From:
To: Selim <Selim@sawayaeng.com>
Cc: Ara Mihranian; Jill Martin <jmartin@trumpnational.com>; Rehm, Zach@Coastal <Zach.Rehm@coastal.ca.gov>
Subject: RE: Tract 50666 Fencing plan

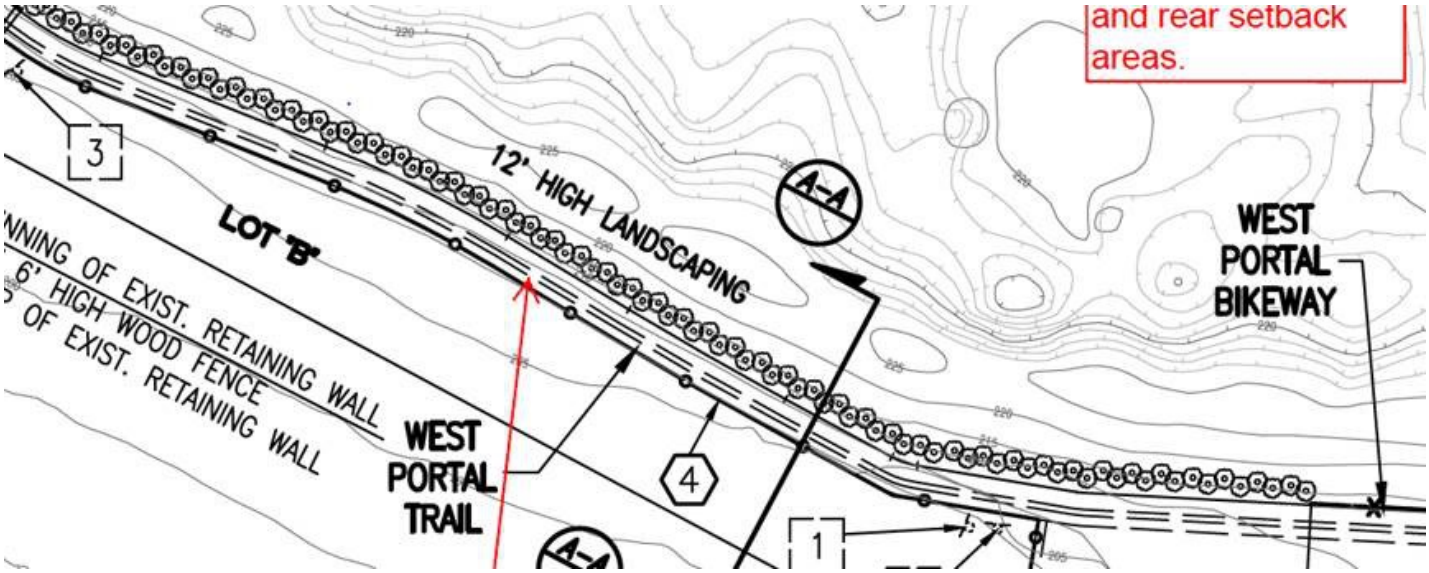
1) Change the notation "12' HIGH LANDSCAPING" to "LANDSCAPING NOT TO EXCEED 12' IN HEIGHT OR THE RIDGE ELEVATION OF THE SOUTHERLY BERM". Based on your map, it appears that the ridge elevation of southerly berm would be 225.

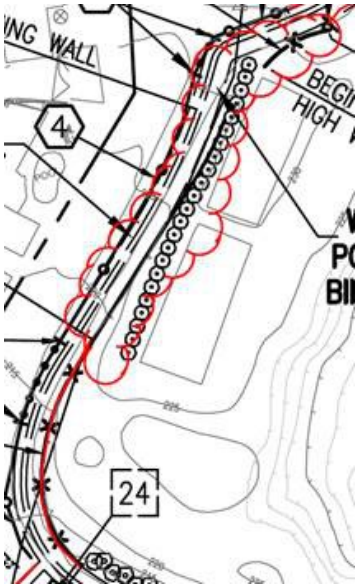
2) Based on Mitigation Measure H-1 above, remove the 6' tall fence
